APPLICATION FOR PERMIT TO DRILL OR REENTER

2. Name of Operator DEVON ENERGY PRODUCTION COMPANY LP (6137)		8. Lease Name and Well No. GREEN WAVE 20-32 FED STATE COM 6H (917795)
3a. Address 333 West Sheridan Avenue Oklahoma City OK 73102	3b. Phone No. (include area code) (800)583-3866	9. API Well No. 90-024-46048 (98094)

# PECOS DISTRICT DRILLING CONDITIONS OF APPROVAL

<b>OPERATOR'S NAME:</b>	DEVON ENERGY PRODUCTION COMPANY LP
<b>LEASE NO.:</b>	NMNM114991
<b>WELL NAME &amp; NO.:</b>	6H – GREEN WAVE 20-32 FED STATE COM
<b>SURFACE HOLE FOOTAGE:</b>	2424'/S & 329'/E
<b>BOTTOM HOLE FOOTAGE:</b>	2486'/N & 1010'/E
<b>LOCATION:</b>	SECTION 20, T26S, R34E, NMPM
<b>COUNTY:</b>	LEA

Figure 1. Cross-sections and plans for typical road sections representative of BLM resource or FS local and higher-class roads.

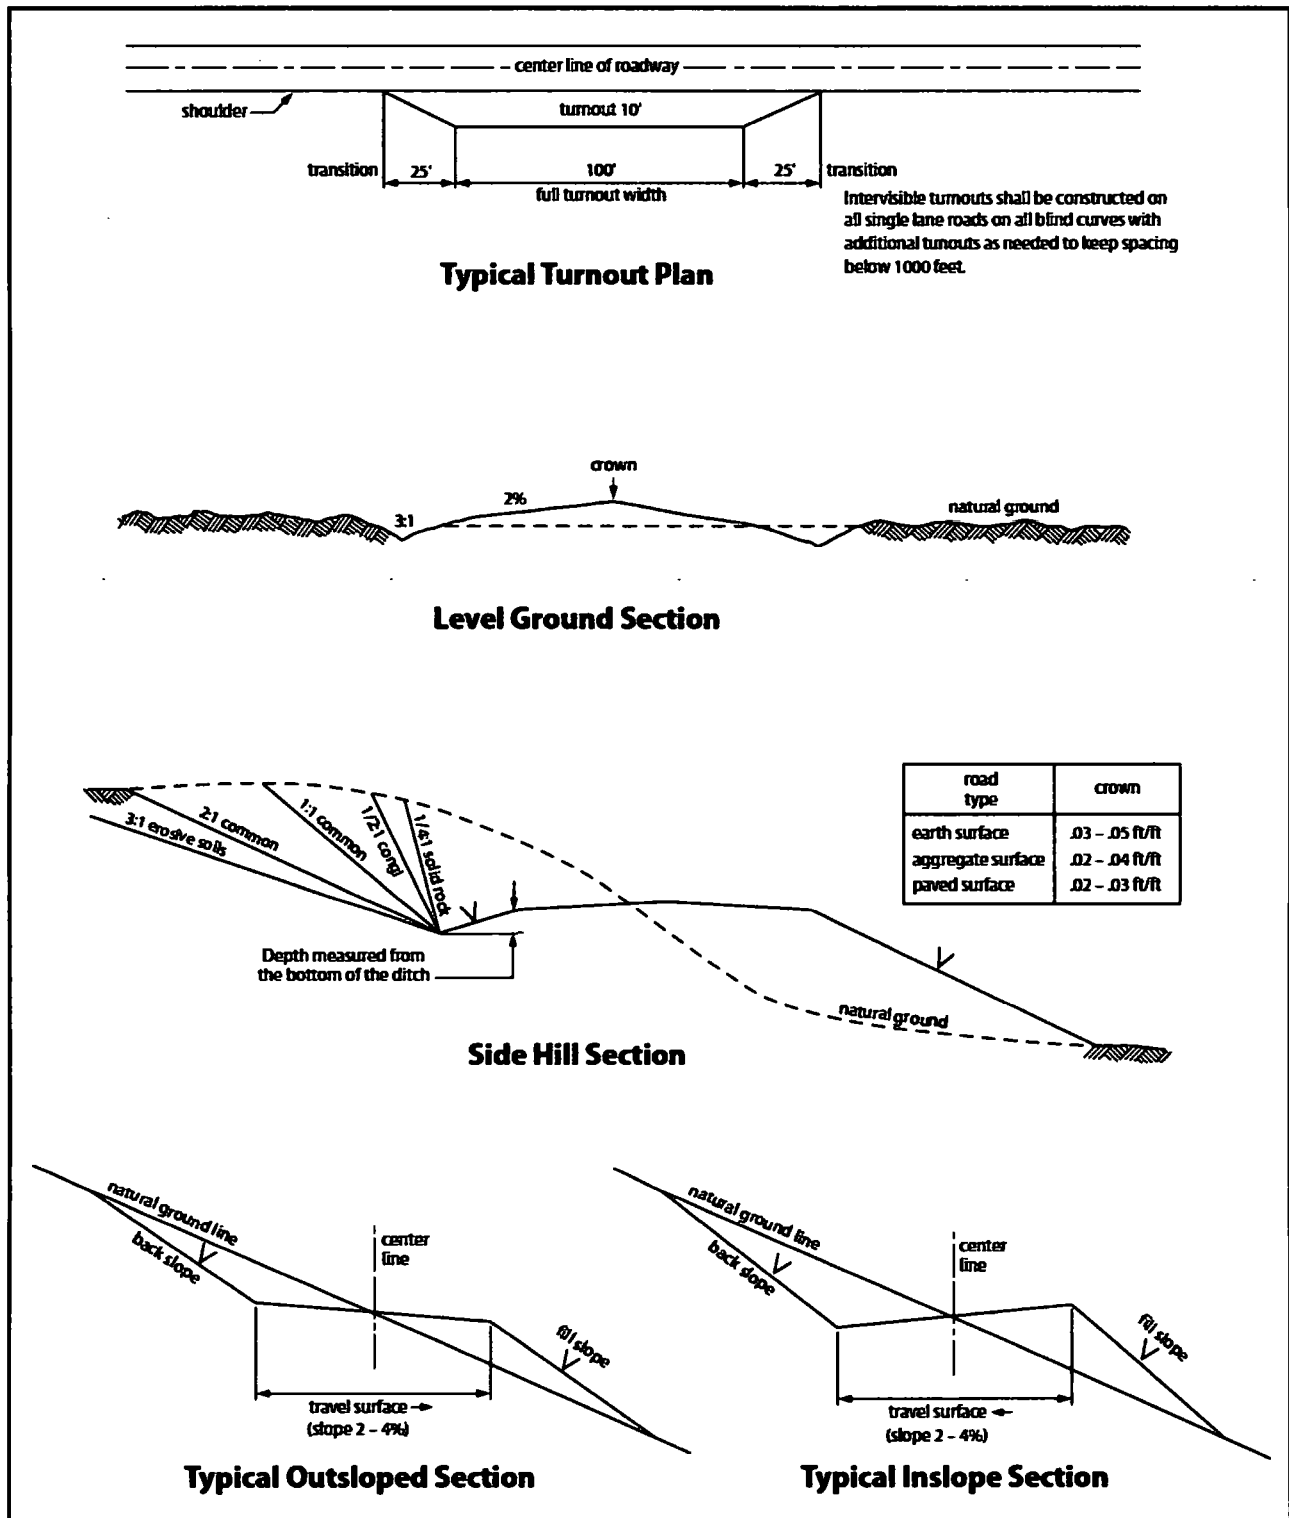
Crowning shall be done on the access road driving surface. The road crown shall have a grade of approximately 2% (i.e., a 1" crown on a 14' wide road). The road shall conform to Figure 1; cross section and plans for typical road construction.

Ditching shall be required on both sides of the road.
